Access Compliance Report

Public Rights-of-Way

(Curb Ramps)

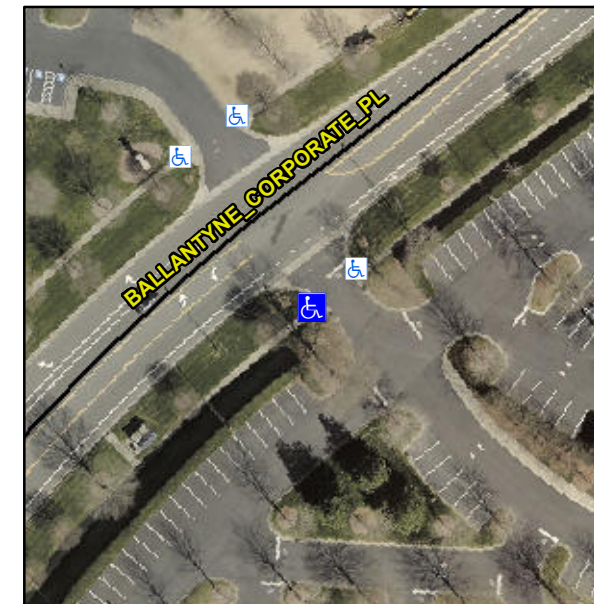
Intersection ID: 10020375	Main Street: BALLANTYNE CORPORATE PL	Cross Street: N/A	Location: SW
ADA ID: D8F3B07248AA	Ramp Type: Perp	Initial Pass/Fail: Fail	Overall Compliance: No
Severity Score: 26.25			
Codes/Mitigation Info/Possible Solution		Field Measurements/Component Compliance

PROW/ADA:

R304.2.2, R304.5.3

Compliance	Description	Data	Compliance	Description	Data
N/A	Ramp Length (in)	52.0	No	Ramp Slope (%)	14.9
Yes	Ramp Width (in)	48.0	No	Ramp XSlope (%)	2.9
N/A	Flare Type LT	N/A	N/A	Flare Type RT	N/A
N/A	Flare Slope LT (%)	N/A	N/A	Flare Slope RT (%)	N/A
N/A	Flare Traversable LT?	N/A	N/A	Flare Traversable RT?	N/A
N/A	Landing Length (in)	N/A	N/A	DWS Provided?	N/A
N/A	Landing Width (in)	N/A	N/A	DWS Contrast?	N/A
N/A	Landing Slope (%)	N/A	N/A	DWS Length (in)	N/A
N/A	Landing X Slope (%)	N/A	N/A	DWS Full Width?	N/A
N/A	Landing Curb? (Y/N)	N/A	N/A	DWS Offset (in)	N/A
N/A	Shared Landing?	N/A			
N/A	Gutter Ponding?	N/A	N/A	Gutter Slope (%)	N/A
N/A	Gutter Lip Ht (in)	N/A	N/A	Gutter X Slope (%)	N/A
N/A	Painted X Walk1?	No	N/A	Painted X Walk2?	N/A
	X Walk 1 Direction	To E		X Walk 2 Direction	N/A
N/A	X Walk 1 Width (in)	N/A	N/A	X Walk 2 Width (in)	N/A
	X Walk 1 Slope (%)	3.9		X Walk 2 Slope (%)	N/A
	X Walk 1 X Slope (%)	6.9		X Walk 2 X Slope (%)	N/A

Possible Solutions:

Remove & Replace Entire Ramp.
